TORNADO-P64xx

F/W rev.1A-1, rev.1A-2 and rev.1B

Addendum #2 to TORNADO-P6x User's Guide rev.4A

covers:
TORNADO-P6414/P6415/P6416 f/w rev.1A-1, rev.1A-2, rev.1B

Fig.2-2d. Construction of *TORNADO-P6414/P6415/P6416* rev.1B board.

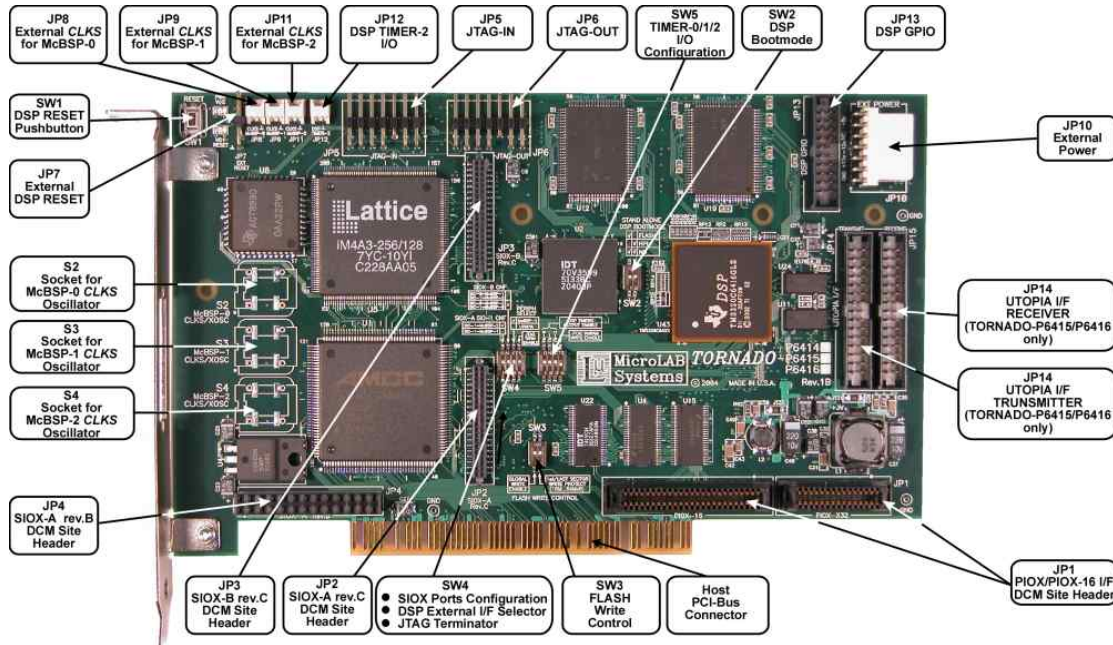
Figure 2-2d below (this figure is an add-on to *TORNADO-P64xx* User’s Guide rev.4A) shows a construction of *TORNADO-P64xx* rev.1B board.

The following is the list of differences in constructions of new *TORNADO-P64xx* rev.1B board and of the *TORNADO-P64xx* rev.1A board, which is covered by *TORNADO-P64xx* User's Guide rev.4A:

- *TORNADO-PX64xxQ* rev.1B board provides the embedded (soldered-in) high-density FLASH memory with 512K..64Mx8 capacity instead of the on-board FLASH/EPROM PLCC-32 socket (S1) for plug-in either 512Kx8 FLASH or 1Mx8 EPROM memory at on *TORNADO-PX64xx* rev.1A board.
- *TORNADO-PX64xxQ* rev.1B provides a modified on-board SW3 switch, which is used for write protection control of on-board FLASH memory. Refer to [section 2.9](#) for more details.
- *TORNADO-PX64xxQ* rev.1B provides the on-board SW5-4 switch, which is used for write protection control of on-board PCIC nvRAM. Refer to [section 2.10](#) for more details.

Fig.A-1d. On-board layout for *TORNADO-P64xx* rev.1B board.

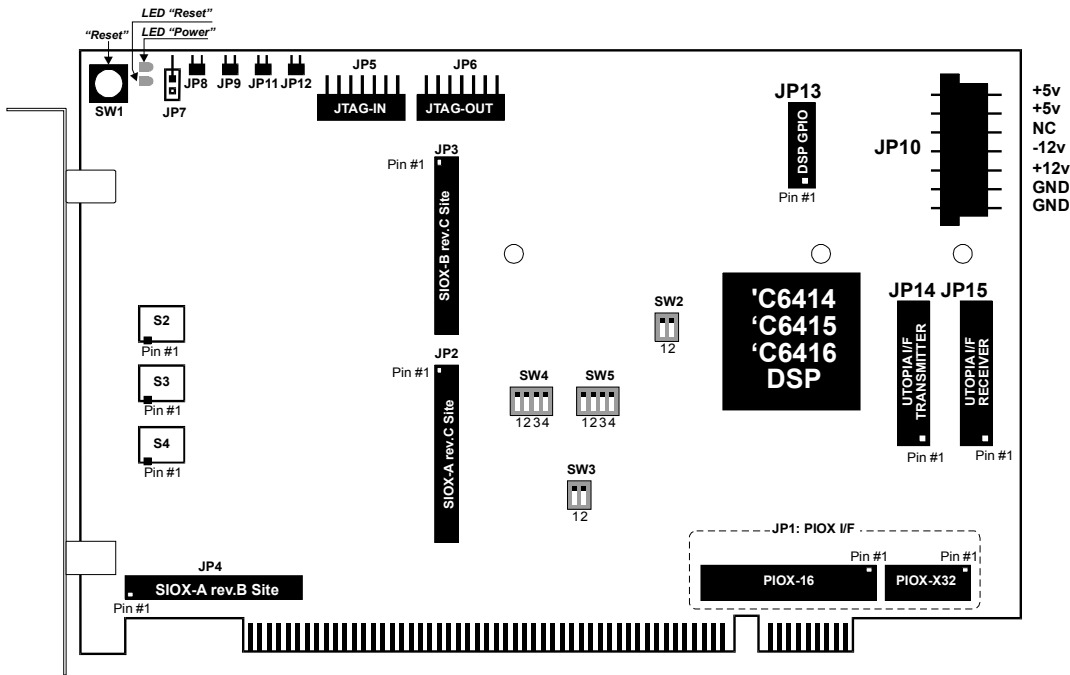
Figure A-1d below (this figure is an add-on to *TORNADO-P64xx* User's Guide rev.4A) shows the on-board layout of configuration switches, connectors, sockets, and LED indicators for *TORNADO-P64xx* rev.1B board.
